RESOLUTION 2025-41

**ORDERING PROVIDING A CONDITIONAL DECLINATION TO REVIEW A
BOUNDARY LINE ADJUSTMENT LOCATED IN THE CITY'S
EXTRATERRITORIAL REVIEW BOUNDARIES.**

CONCEPT 4

LOTS 8 & 9 SUBDIVISION OF LOT 4
 SLACH'S COMMERCIAL SUBDIVISION
 WEST BRANCH
 CEDAR COUNTY, IOWA

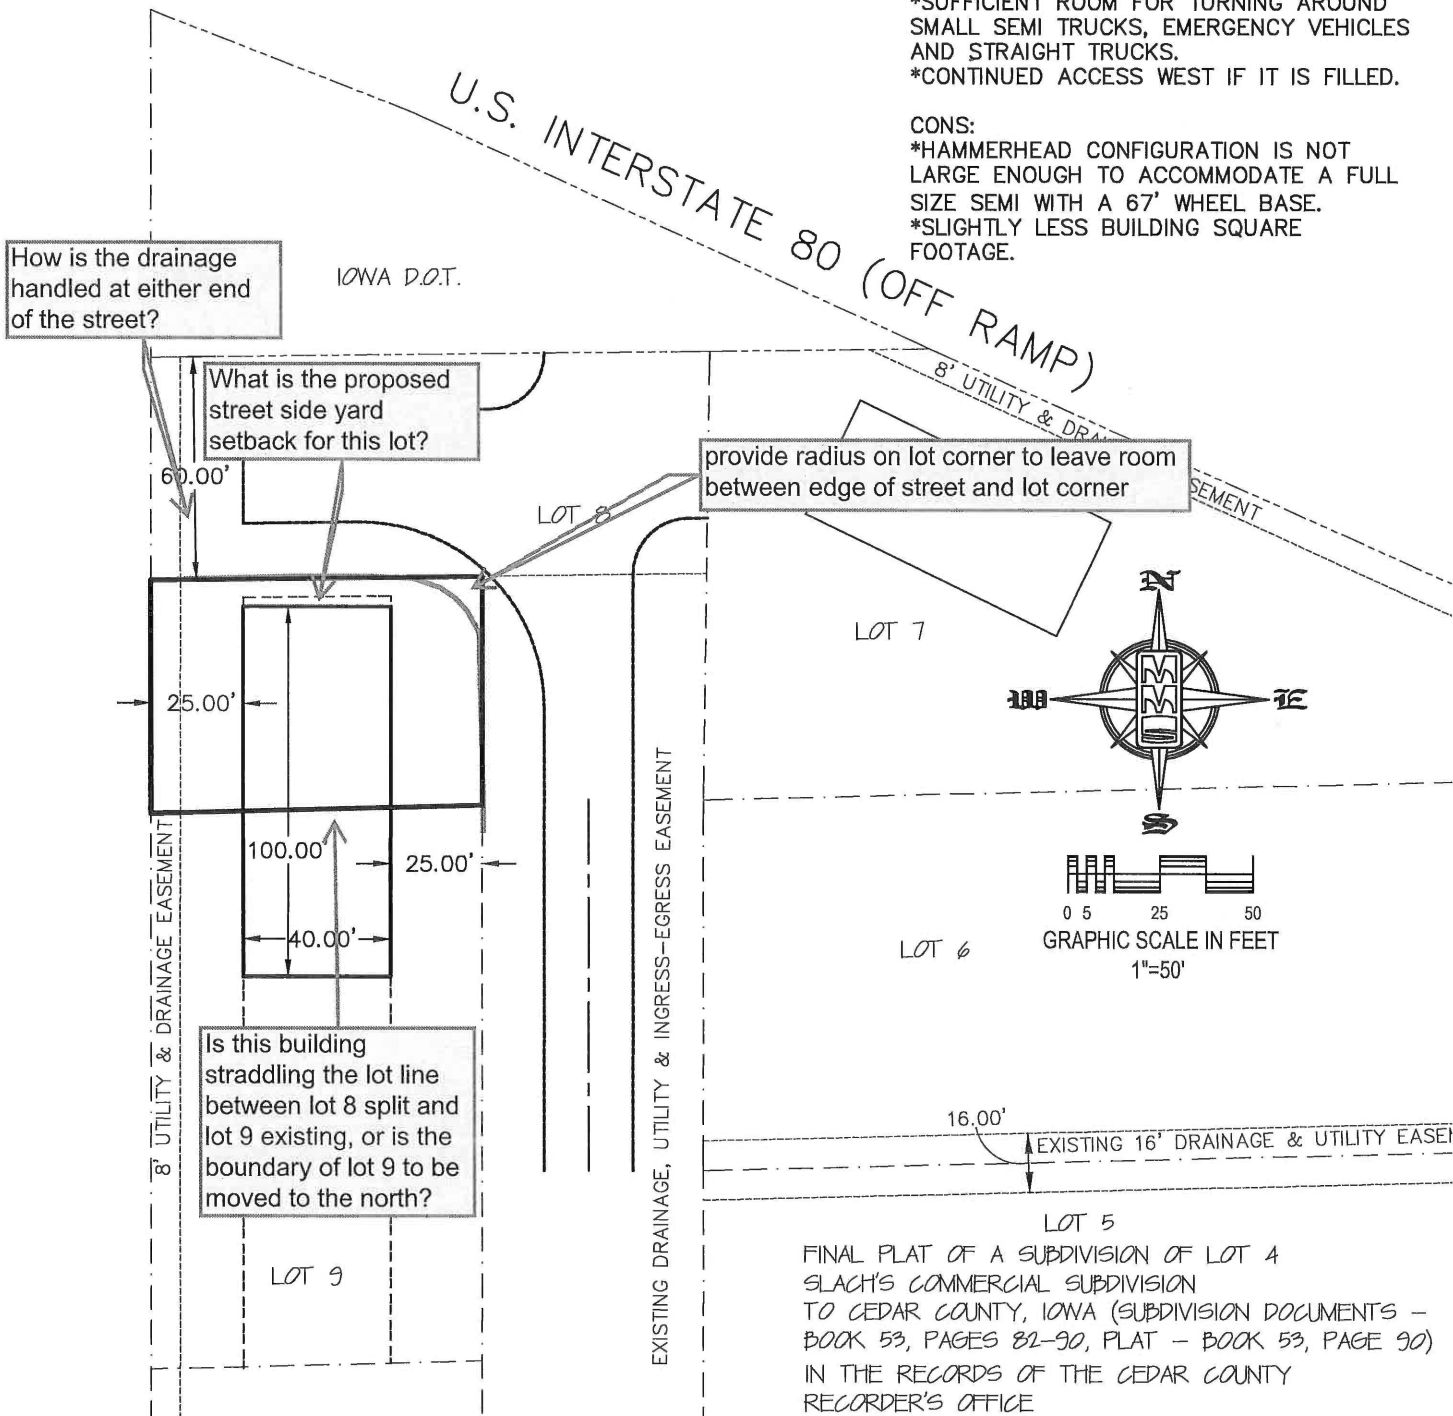
How is the drainage handled at either end of the street?

What is the proposed street side yard setback for this lot?

provide radius on lot corner to leave room between edge of street and lot corner

Is this building straddling the lot line between lot 8 split and lot 9 existing, or is the boundary of lot 9 to be moved to the north?
